INITIAL FIRE SAFETY INSPECTION REPORT

Vision Garments Ltd. (New Building)

RSC ID: 24674

Date: 25 September-2023

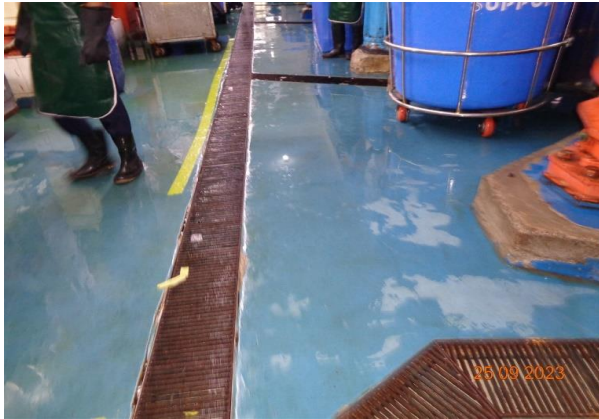
F-6	Fire Rated Construction	Dining area is not separated from storage area on basement.	Separate the dining room by a minimum 3-hr fire-rated construction as per BNBC 2006, table:3.2.1. Seal and/or protect all openings to maintain the required fire separations. Also follow RSC Technical Guidelines StandardV1.0 article 3.3.4 Occupancy E: Assembly Buildings for capacity.	Within 3 Month
-----	-------------------------	---	---	----------------
